就規劃申請/覆核提出意見 Making Comment on Planning Application / Review

Y/I-DB/2

Comments on the Second Further Information Submitted in Support of Section 12A Application Number Y/I-DB/2 to amend Discovery Bay Outline Zoning Plan for rezoning the permissible use from staff quarters to flats at Area 6f, Discovery Bay.

View of the open nullah looking downstream towards Hillgrove Village

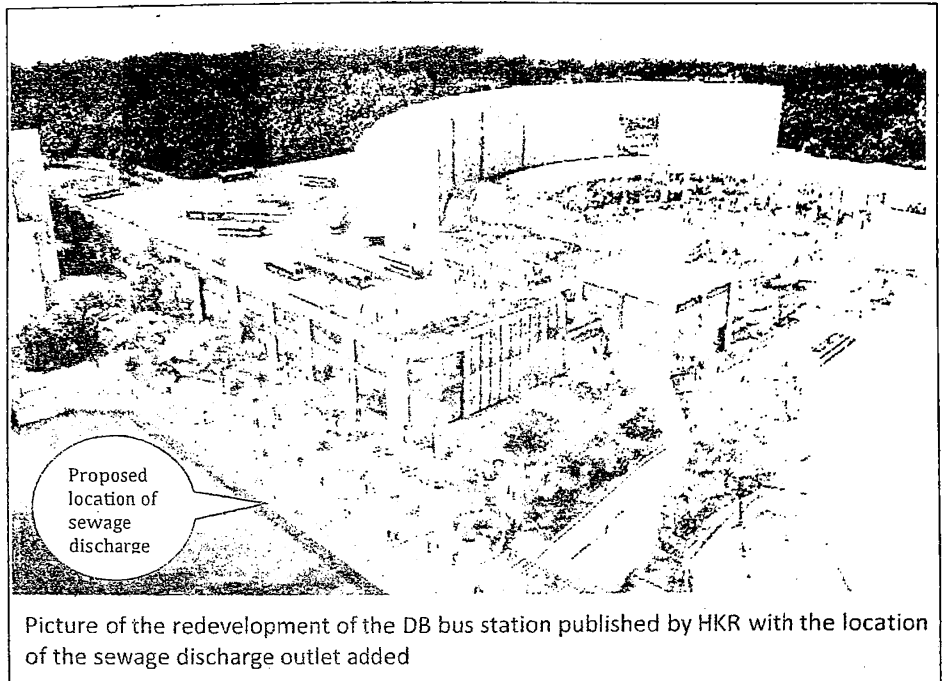
1. HKR is still saying, as it did in its previous submissions, that discharging the treated sewage directly into an open nullah is still an option to be considered at the design stage. This open nullah is parallel to Discovery Valley Road and proceeds directly in front of Hillgrove Village. Therefore, every day 440 m³ per day of sewage will be flowing

2. The nullah serves the dual purpose of a storm water channel and as an overflow relief for the reservoir at the top of Discovery Valley Road. Normally it is virtually empty, but during periods of rainstorm and/or reservoir discharge this nullah is full to the top. The addition of the sewage effluent to the storm water flow may cause the nullah to overflow or the effluent to back-up into the STW, both with serious health implications. This option would appear to be cheaper than building a gravity sewage pipe and it is considered that HKR will adopt this option whilst giving the impression to the TPB, EPD, etc. that it will build a gravity pipe, which would presumably put the sewage flow underground.

View of the open nullah looking downstream towards Hillgrove Village

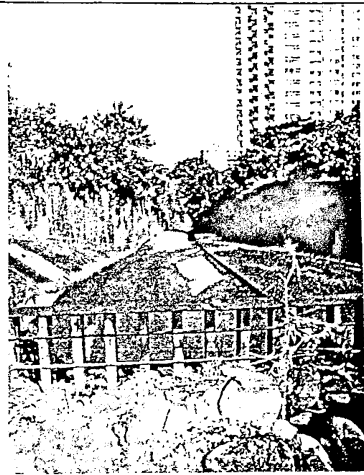
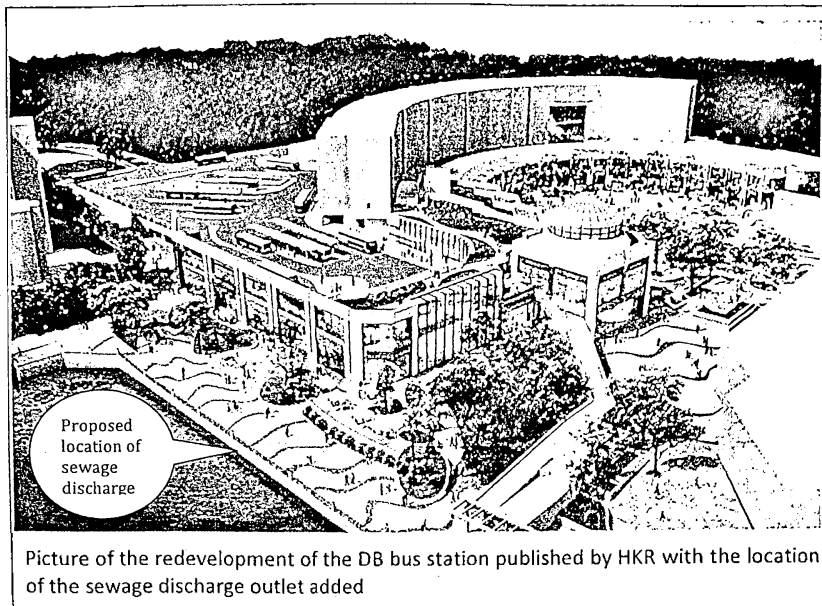
alongside approximately 200 metres of footpath/road and directly under the balconies of around 200 apartments in this village. This is illustrated in the following photographs.

2. The nullah serves the dual purpose of a storm water channel and as an overflow relief for the reservoir at the top of Discovery Valley Road. Normally it is virtually empty, but during periods of rainstorm and/or reservoir discharge this nullah is full to the top. The addition of the sewage effluent to the storm water flow may cause the nullah to overflow or the effluent to back-up into the STW, both with serious health implications. This option would appear to be cheaper than building a gravity sewage pipe and it is considered that HKR will adopt this option whilst giving the impression to the TPB, EPD, etc. that it will build a gravity pipe, which would presumably put the sewage flow underground.

View of the open nullah looking downstream towards Hillgrove Village

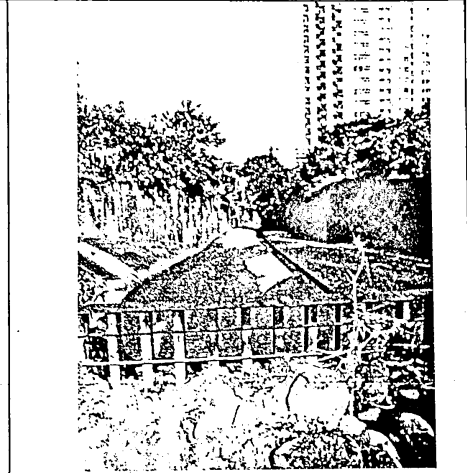
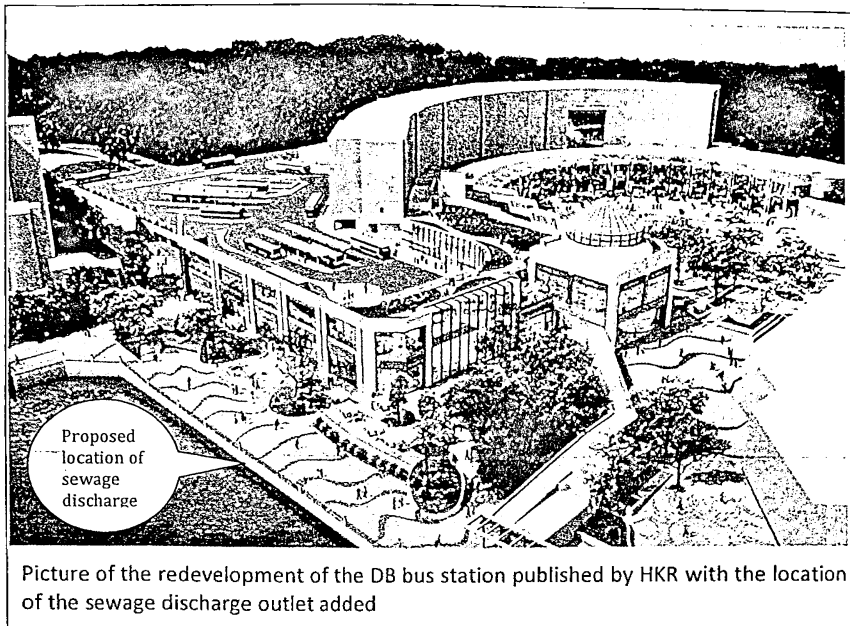
alongside approximately 200 metres of footpath/road and directly under the balconies of around 200 apartments in this village. This is illustrated in the following photographs.

2. The nullah serves the dual purpose of a storm water channel and as an overflow relief for the reservoir at the top of Discovery Valley Road. Normally it is virtually empty, but during periods of rainstorm and/or reservoir discharge this nullah is full to the top. The addition of the sewage effluent to the storm water flow may cause the nullah to overflow or the effluent to back-up into the STW, both with serious health implications. This option would appear to be cheaper than building a gravity sewage pipe and it is considered that HKR will adopt this option whilst giving the impression to the TPB, EPD, etc. that it will build a gravity pipe, which would presumably put the sewage flow underground.

View of the open nullah looking downstream towards Hillgrove Village

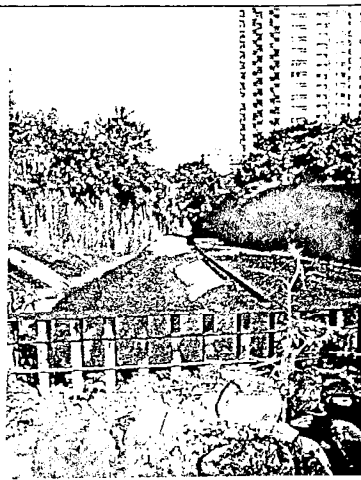
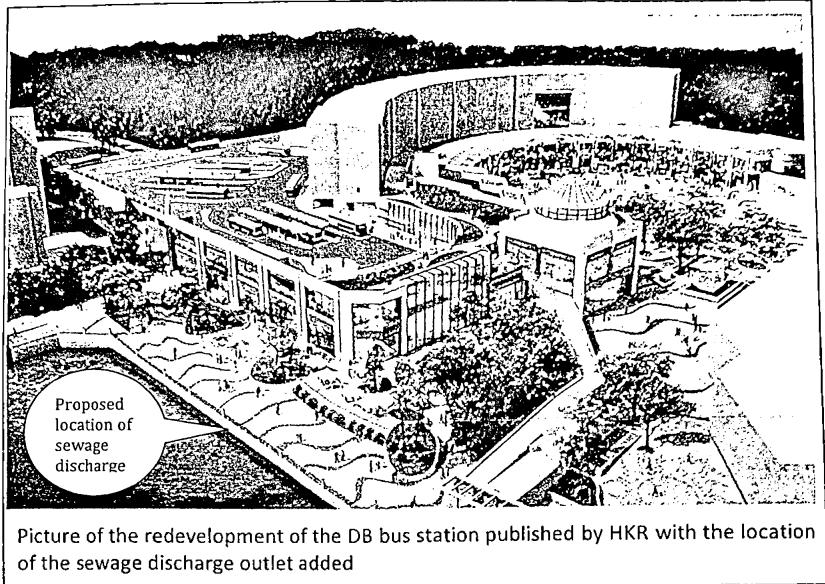
alongside approximately 200 metres of footpath/road and directly under the balconies of around 200 apartments in this village. This is illustrated in the following photographs.

2. The nullah serves the dual purpose of a storm water channel and as an overflow relief for the reservoir at the top of Discovery Valley Road. Normally it is virtually empty, but during periods of rainstorm and/or reservoir discharge this nullah is full to the top. The addition of the sewage effluent to the storm water flow may cause the nullah to overflow or the effluent to back-up into the STW, both with serious health implications. This option would appear to be cheaper than building a gravity sewage pipe and it is considered that HKR will adopt this option whilst giving the impression to the TPB, EPD, etc. that it will build a gravity pipe, which would presumably put the sewage flow underground.

View of the open nullah looking downstream towards Hillgrove Village

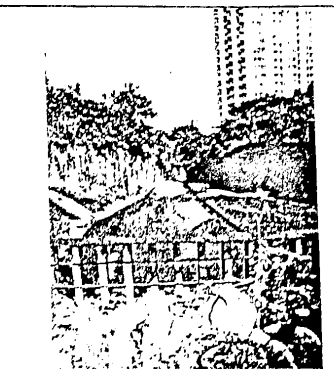
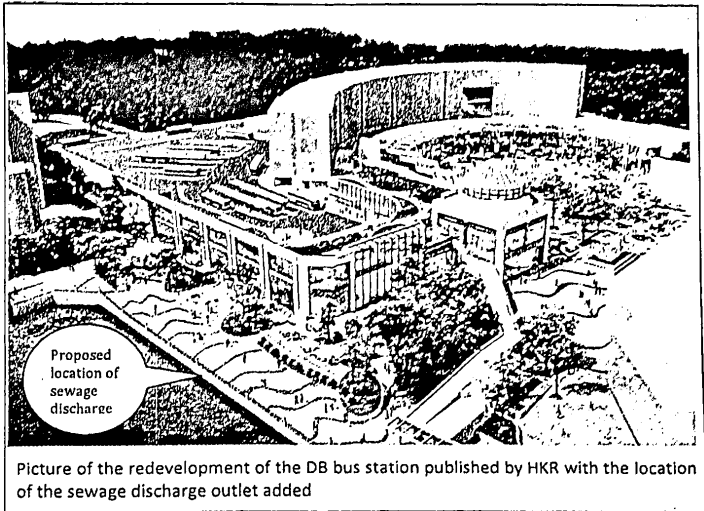
alongside approximately 200 metres of footpath/road and directly under the balconies of around 200 apartments in this village. This is illustrated in the following photographs.

2. The nullah serves the dual purpose of a storm water channel and as an overflow relief for the reservoir at the top of Discovery Valley Road. Normally it is virtually empty, but during periods of rainstorm and/or reservoir discharge this nullah is full to the top. The addition of the sewage effluent to the storm water flow may cause the nullah to overflow or the effluent to back-up into the STW, both with serious health implications. This option would appear to be cheaper than building a gravity sewage pipe and it is considered that HKR will adopt this option whilst giving the impression to the TPB, EPD, etc. that it will build a gravity pipe, which would presumably put the sewage flow underground.

View of the open nullah looking downstream towards Hillgrove Village

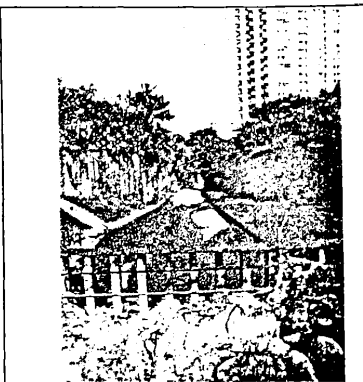
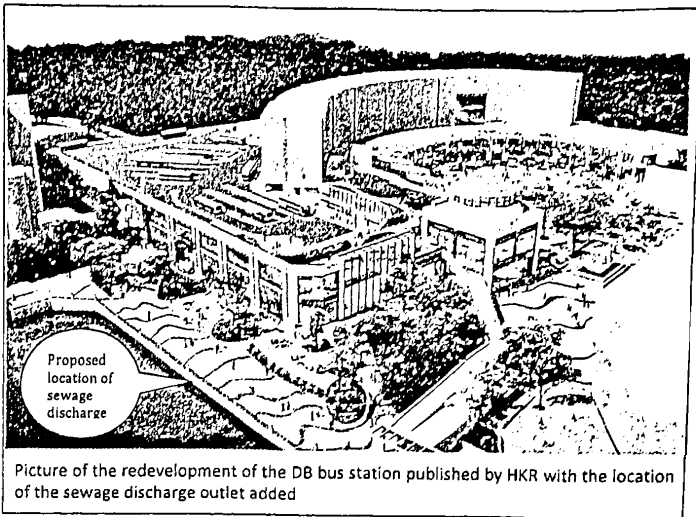
alongside approximately 200 metres of footpath/road and directly under the balconies of around 200 apartments in this village. This is illustrated in the following photographs.

2. The nullah serves the dual purpose of a storm water channel and as an overflow relief for the reservoir at the top of Discovery Valley Road. Normally it is virtually empty, but during periods of rainstorm and/or reservoir discharge this nullah is full to the top. The addition of the sewage effluent to the storm water flow may cause the nullah to overflow or the effluent to back-up into the STW, both with serious health implications. This option would appear to be cheaper than building a gravity sewage pipe and it is considered that HKR will adopt this option whilst giving the impression to the TPB, EPD, etc. that it will build a gravity pipe, which would presumably put the sewage flow underground.

View of the open nullah looking downstream towards Hillgrove Village

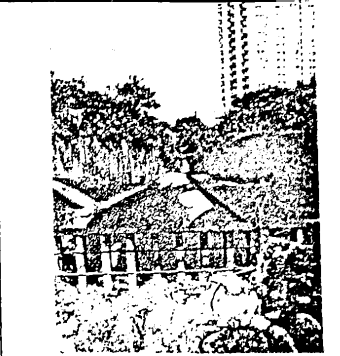
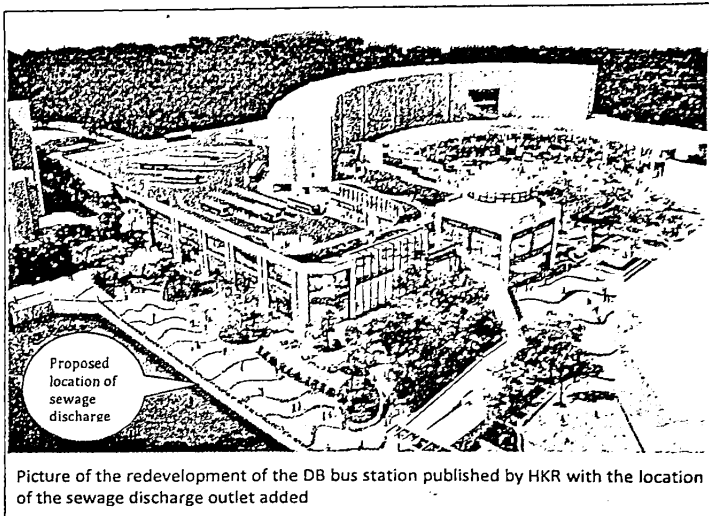
alongside approximately 200 metres of footpath/road and directly under the balconies of around 200 apartments in this village. This is illustrated in the following photographs.

2. The nullah serves the dual purpose of a storm water channel and as an overflow relief for the reservoir at the top of Discovery Valley Road. Normally it is virtually empty, but during periods of rainstorm and/or reservoir discharge this nullah is full to the top. The addition of the sewage effluent to the storm water flow may cause the nullah to overflow or the effluent to back-up into the STW, both with serious health implications. This option would appear to be cheaper than building a gravity sewage pipe and it is considered that HKR will adopt this option whilst giving the impression to the TPB, EPD, etc. that it will build a gravity pipe, which would presumably put the sewage flow underground.

View of the open nullah looking downstream towards Hillgrove Village

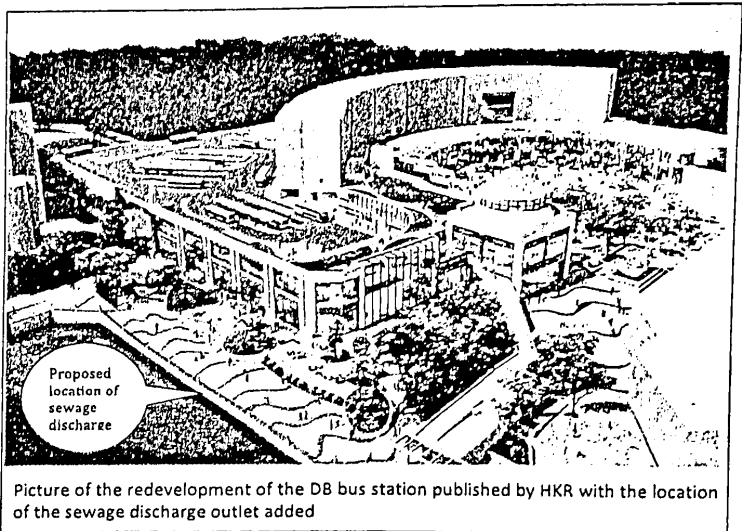
2. The nullah serves the dual purpose of a storm water channel and as an overflow relief for the reservoir at the top of Discovery Valley Road. Normally it is virtually empty, but during periods of rainstorm and/or reservoir discharge this nullah is full to the top. The addition of the sewage effluent to the storm water flow may cause the nullah to overflow or the effluent to back-up into the STW, both with serious health implications. This option would appear to be cheaper than building a gravity sewage pipe and it is considered that HKR will adopt this option whilst giving the impression to the TPB, EPD, etc. that it will build a gravity pipe, which would presumably put the sewage flow underground.

View of the open nullah looking downstream towards Hillgrove Village

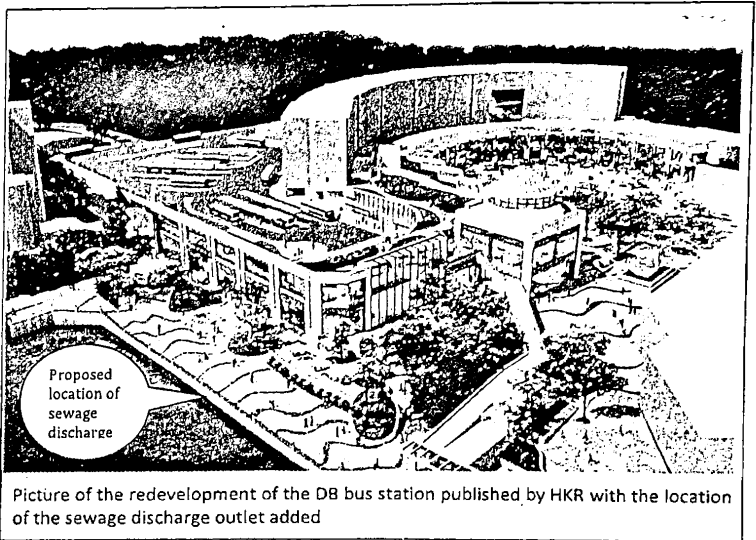
alongside approximately 200 metres of footpath/road and directly under the balconies of around 200 apartments in this village. This is illustrated in the following photographs.

2. The nullah serves the dual purpose of a storm water channel and as an overflow relief for the reservoir at the top of Discovery Valley Road. Normally it is virtually empty, but during periods of rainstorm and/or reservoir discharge this nullah is full to the top. The addition of the sewage effluent to the storm water flow may cause the nullah to overflow or the effluent to back-up into the STW, both with serious health implications. This option would appear to be cheaper than building a gravity sewage pipe and it is considered that HKR will adopt this option whilst giving the impression to the TPB, EPD, etc. that it will build a gravity pipe, which would presumably put the sewage flow underground.

View of the open nullah looking downstream towards Hillgrove Village

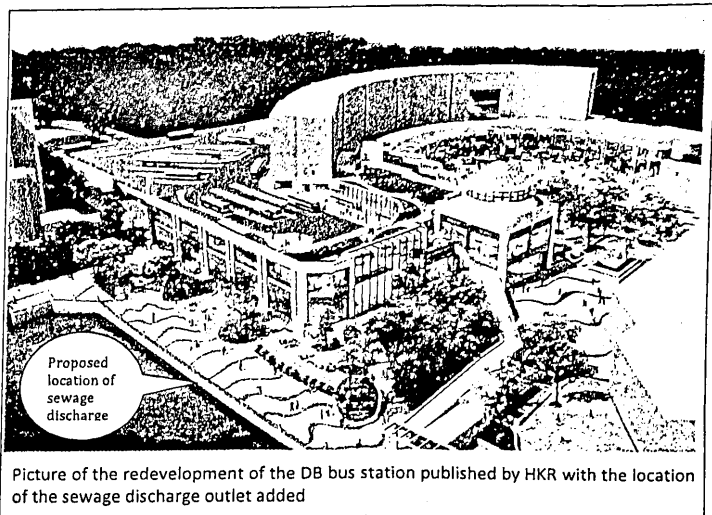
2. The nullah serves the dual purpose of a storm water channel and as an overflow relief for the reservoir at the top of Discovery Valley Road. Normally it is virtually empty, but during periods of rainstorm and/or reservoir discharge this nullah is full to the top. The addition of the sewage effluent to the storm water flow may cause the nullah to overflow or the effluent to back-up into the STW, both with serious health implications. This option would appear to be cheaper than building a gravity sewage pipe and it is considered that HKR will adopt this option whilst giving the impression to the TPB, EPD, etc. that it will build a gravity pipe, which would presumably put the sewage flow underground.

View of the open nullah looking downstream towards Hillgrove Village

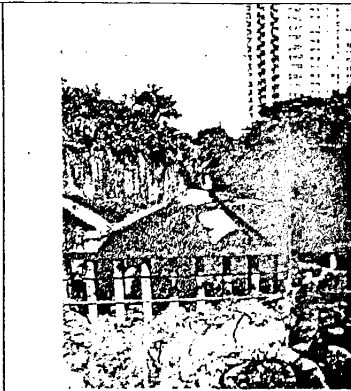
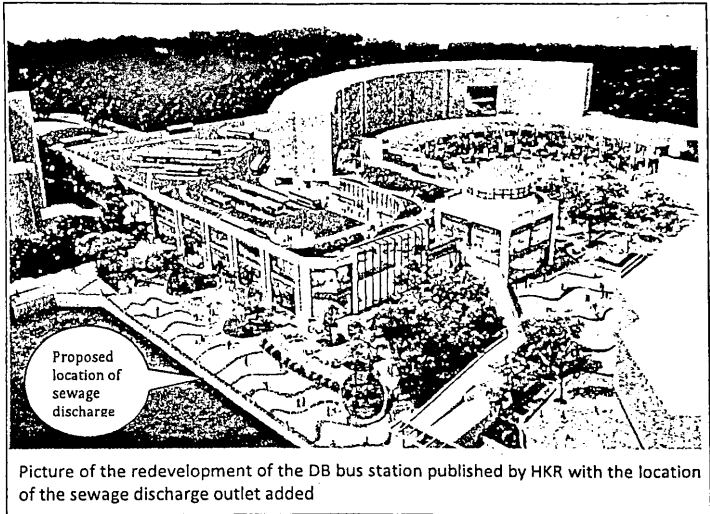
alongside approximately 200 metres of footpath/road and directly under the balconies of around 200 apartments in this village. This is illustrated in the following photographs.

2. The nullah serves the dual purpose of a storm water channel and as an overflow relief for the reservoir at the top of Discovery Valley Road. Normally it is virtually empty, but during periods of rainstorm and/or reservoir discharge this nullah is full to the top. The addition of the sewage effluent to the storm water flow may cause the nullah to overflow or the effluent to back-up into the STW, both with serious health implications. This option would appear to be cheaper than building a gravity sewage pipe and it is considered that HKR will adopt this option whilst giving the impression to the TPB, EPD, etc. that it will build a gravity pipe, which would presumably put the sewage flow underground.

View of the open nullah looking downstream towards Hillgrove Village

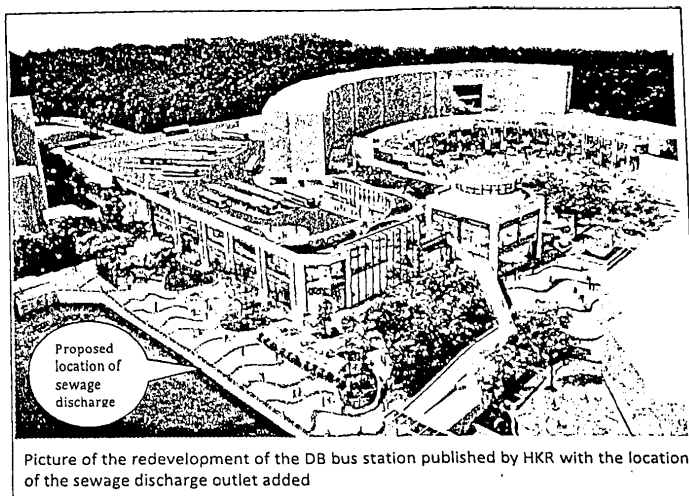
2. The nullah serves the dual purpose of a storm water channel and as an overflow relief for the reservoir at the top of Discovery Valley Road. Normally it is virtually empty, but during periods of rainstorm and/or reservoir discharge this nullah is full to the top. The addition of the sewage effluent to the storm water flow may cause the nullah to overflow or the effluent to back-up into the STW, both with serious health implications. This option would appear to be cheaper than building a gravity sewage pipe and it is considered that HKR will adopt this option whilst giving the impression to the TPB, EPD, etc. that it will build a gravity pipe, which would presumably put the sewage flow underground.
